# Service Bulletin

**SUBJECT:** Service Update for Inventory and Customer Vehicles  
Front Bumper Fascia Air Deflector Replacement  
Expires with Base Warranty

**MODELS:** 2013 Chevrolet Malibu  
Equipped with Active Grille Shutters (VRI) and Located in Alabama,  
Arkansas, Arizona, Florida, Georgia, Louisiana, Mississippi, New Mexico,  
Oklahoma, South Carolina, Texas, and Israel

2717668

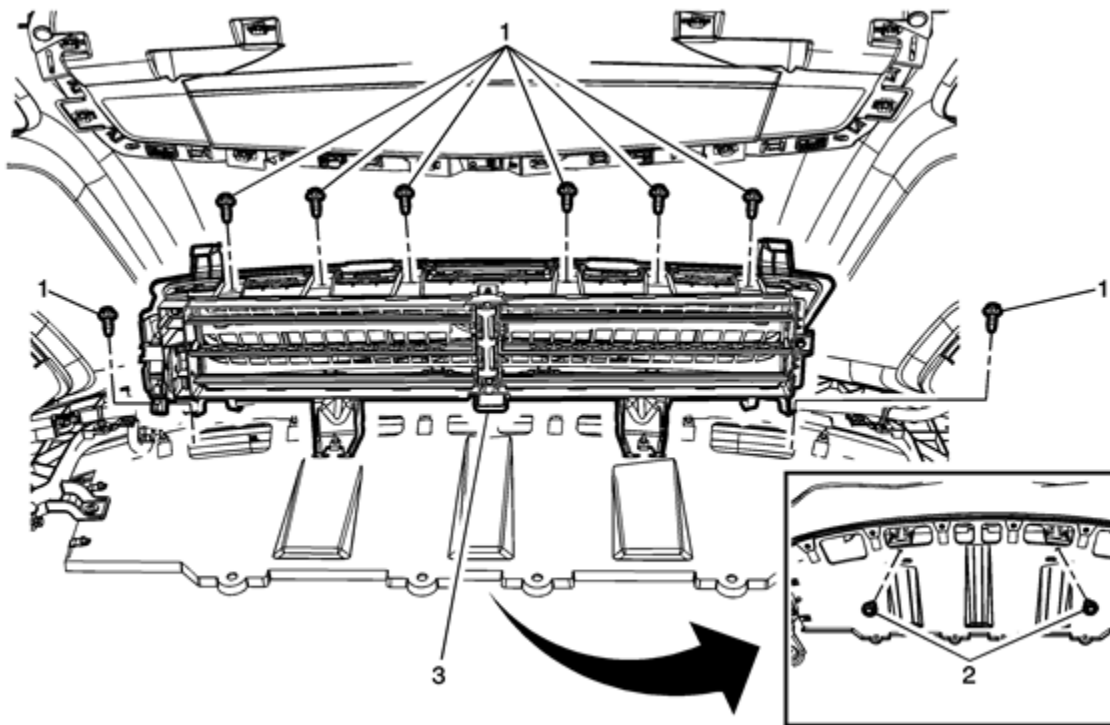
This bulletin provides a service procedure to replace the front bumper fascia air deflector on **certain** 2013 model year Chevrolet Malibu vehicles that are equipped with active grille shutters (VRI) and located in the following hot weather areas: Alabama, Arkansas, Arizona, Florida, Georgia, Louisiana, Mississippi, New Mexico, Oklahoma, South Carolina, Texas, and Israel. The front grille shutter actuator on these vehicles may exceed the actuator's angular tolerance range. This could cause the illumination of the Service Engine Soon lamp; however it does not affect the operation of the grille shutter assembly and it will continue to operate properly.

1. Remove the front bumper fascia air deflector from the vehicle. Refer to *Front Bumper Fascia Air Deflector* in SI.
2. Install a new front bumper fascia air deflector. Refer to *Front Bumper Fascia Air Deflector* in SI.
